# 8006 SEGMENTTIMER Controller Plate

CONTROLLER PLATE BEHIND FACE

Scoreboard Type: 100

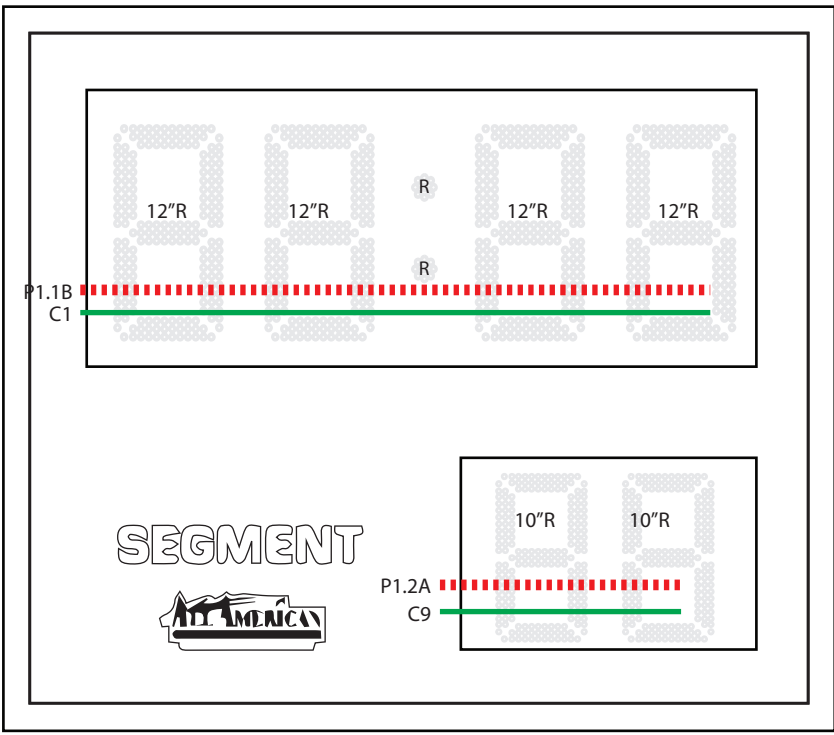
**Revised on 6/7/13**  
 Changed from type 400 to type 100 and moved segment output from 2 to 9. This will accommodate both football (timer/dog timer) and segment timing.  
 No firmware change needed.
